## New came and new inner door frame in compact microwaves ovens

MW 32 BIS - MW 32 BIT and MC 32 BIS

All microwave ovens produced after 06-11-2007 (Came) y 30-11-2007 (Inner Door Frame).

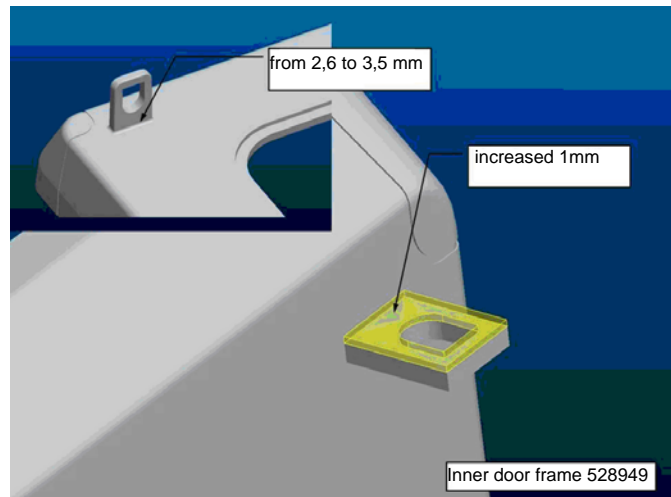
- Came turned to the safety position in a consequence of reduced inter-action between hook and came. In consequence of this fast movement were identified occurrences of spring out of position.
  - Microwave stop during normal use in consequence of instable micro switches action
1. Replace Right Came and Left Came for a new ones

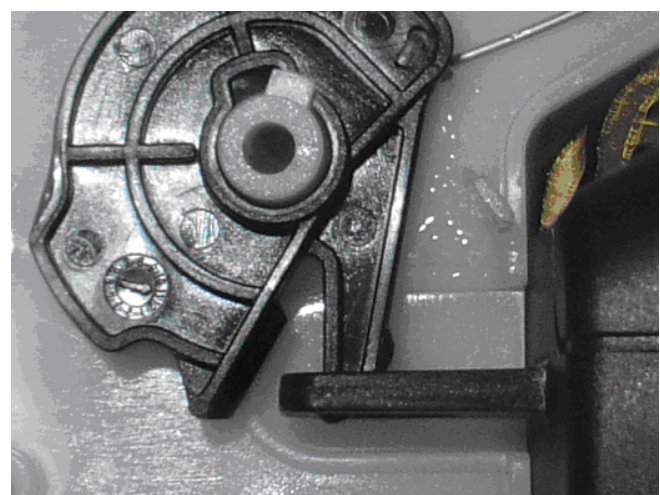
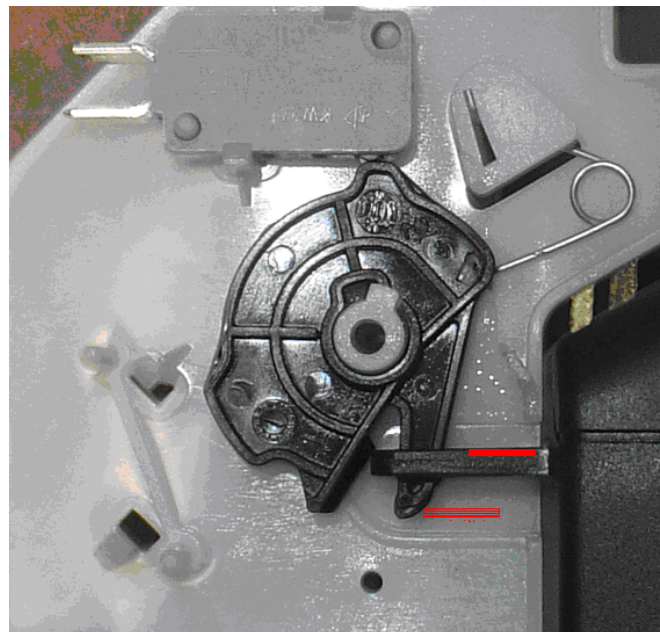
2. Replace Inner Door Frame for a new version  
Thickness increased 1mm and base reinforced.

With these improvements we assure an adequate mechanical action on the came resulting a good working stability. Extreme working positions will be controlled by the hook without the possibility of came returning to the safety position after hook freedom.

Hook configuration more strong, reducing accidental broken occurrences

Inner door frame: 528949

Came: 528927
